SPEATH ENGINEERING

RE: Port Pheonix Water Way Marina – DCI2023-00054 – Major PD

Please find below responses and commentary to the provided comments from staff in your July 18th, 2025 letter regarding the Commercial Planned Development Application for Port Pheonix Water Way Marina (DCI2023-00054).

$$\begin{array}{c} MCP \\ 1 \quad OF \quad 1 \end{array}$$

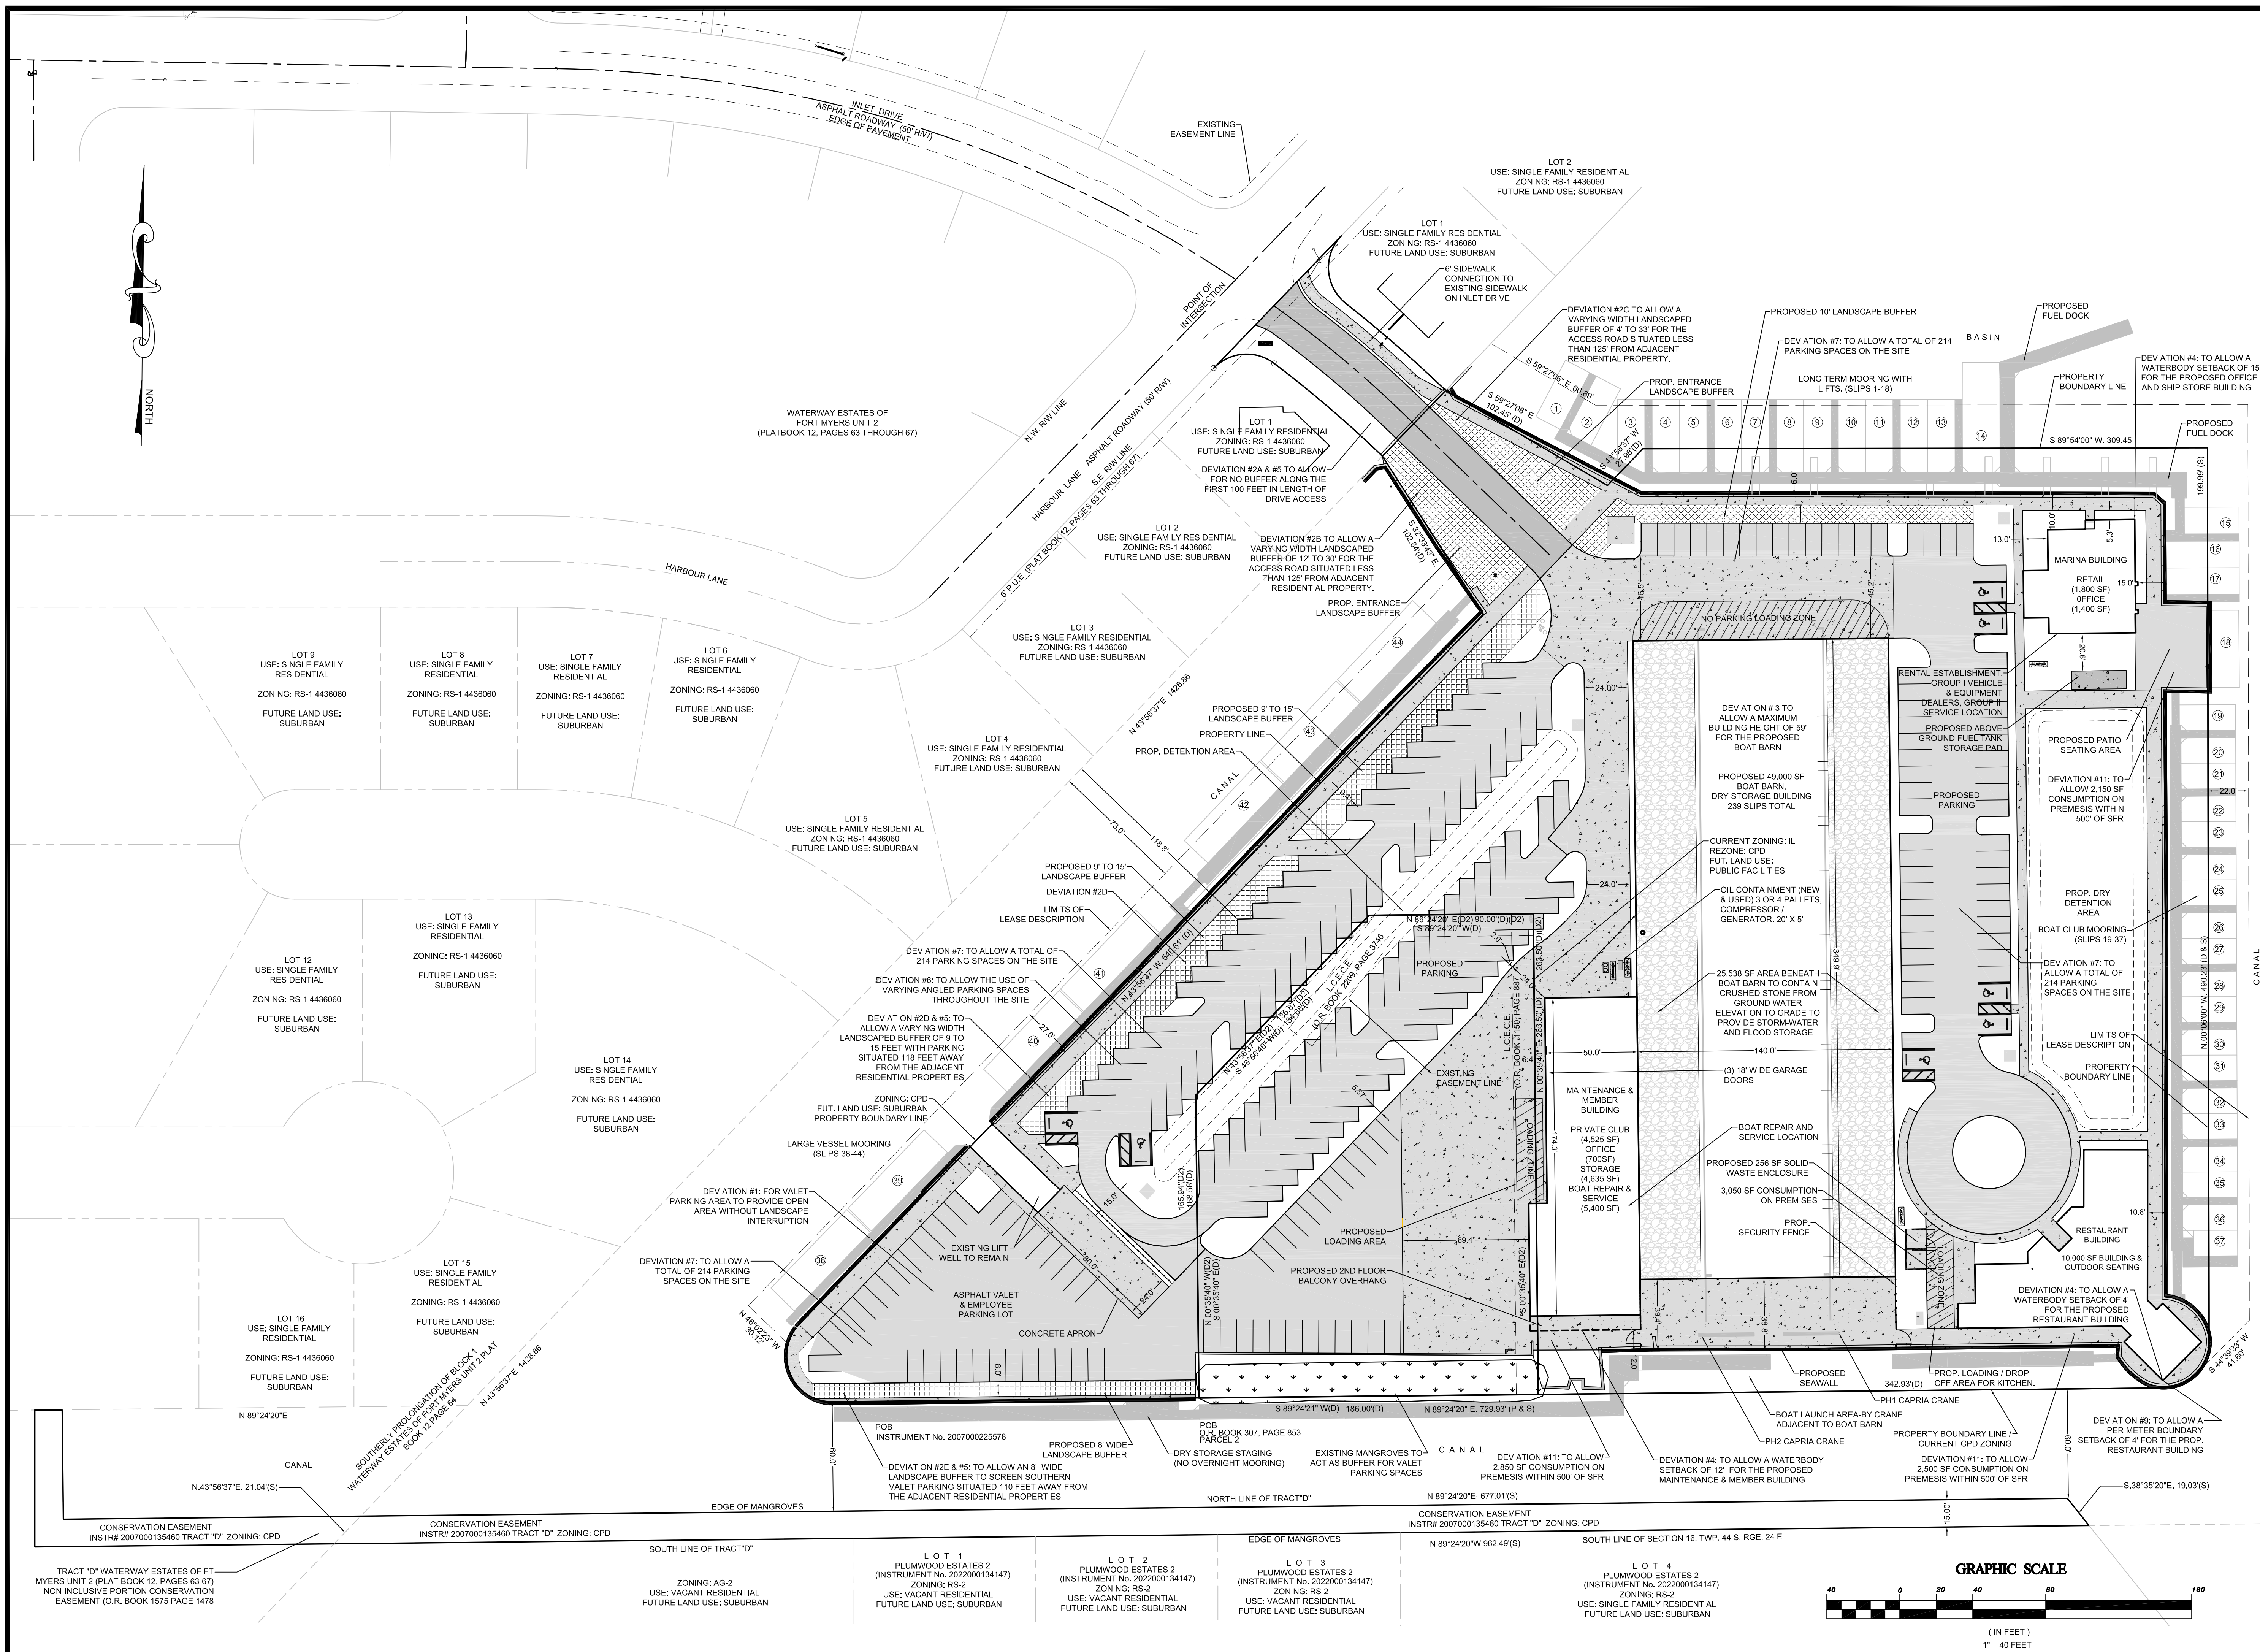
1. *REPEAT COMMENT: The darkened line showing the area to be rezoned on the MCP does not match the legal description of the area to be rezoned. Please see the legal description and revise the darkened line on the MCP to match.*

- b. *Second Condition: On Inlet Drive and Harbour Lane, provide No Parking Tow Away Zone signage providing the name and telephone number of the tow company responsible for towing. (7/18/2025 JM)*

Please refer to the revised MCP, where the L-shaped section has been removed from the area to be rezoned. This revision ensures that the plans now align with the Z-06-065 approved sketch and legal description, as well as the legal description in the DCI2023-00054 case file. Note, the latest sketch and legal description does not contain this L-shape portion and is correct as previously filed.

Call outs requiring No Parking Tow Away Zone signage have been added to the MCP. Specific sign locations and details will be provided at the time of Development Order.
